**WORKING GROUP MEETING MINUTES
MEETING OF SPECIAL COMMITTEE 231**

TAWS - GPWS

Date: 22-24 September 2015

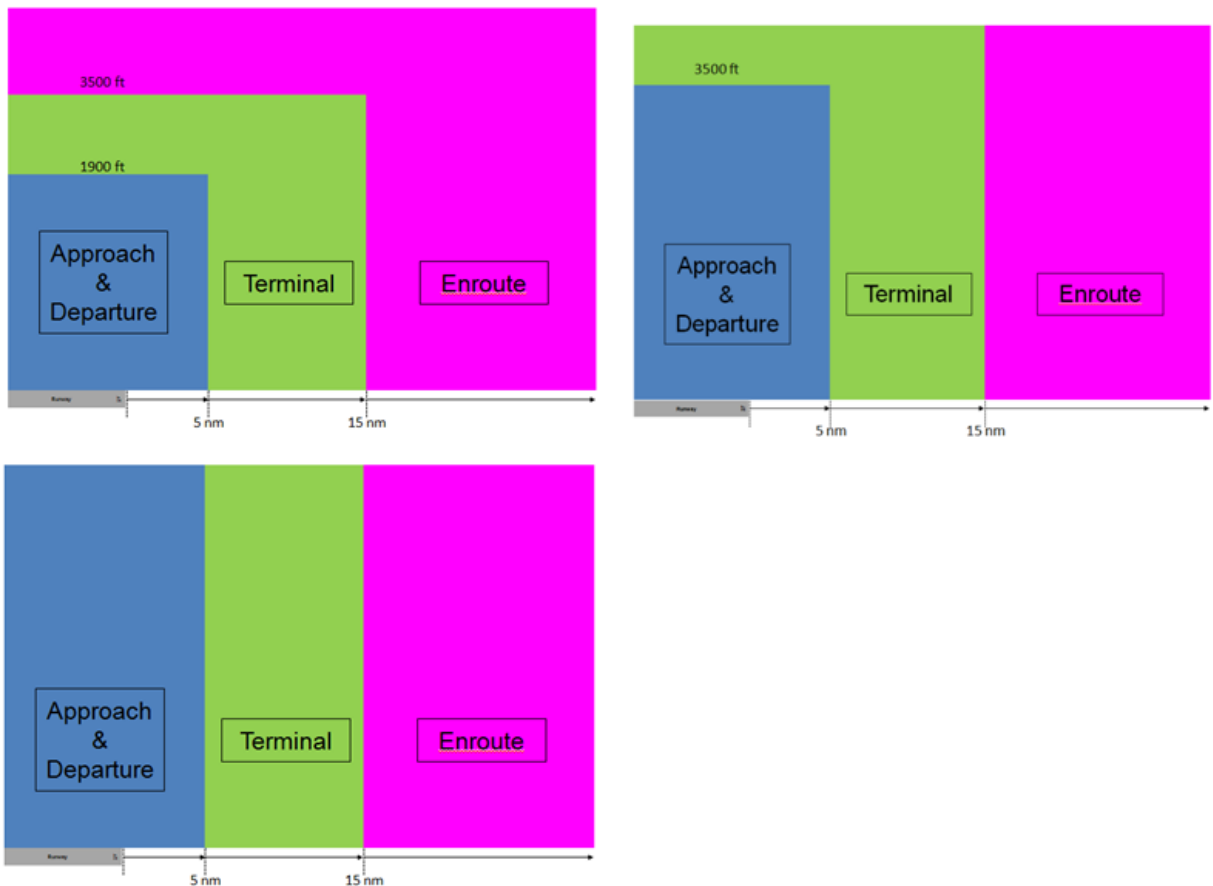
The question is asked about what alerting modes change based on phase of flight. However, one supplier points out that the phase of flight requirement has nothing to do with FLTA. The phase of flight is not used on this supplier's system.

A review was made of a proposed change to the Phase of Flight area, where a distance only implementation is described with no altitude limit. A slide was developed indicating the existing standards and the respective limits of the systems, where the caps on the approach area and the caps on the terminal area can be unlimited in some systems. Basically, the separate implementations are summarized below:

We are trying to determine how critical this phase of flight definition is to the overall alerting.

We are asking how these phases of flight are used in the document. They are only used as the means to identify the Table A through Table F test cases defined at these Phases of Flight. The Departure phase appears to be unused in test cases elsewhere in the TSO document, but described in the Required Obstacle Clearance table 3.1.1. Perhaps a take-off definition is needed.

An action was created above named "Phase of Flight Assessment" to develop a more informed position.
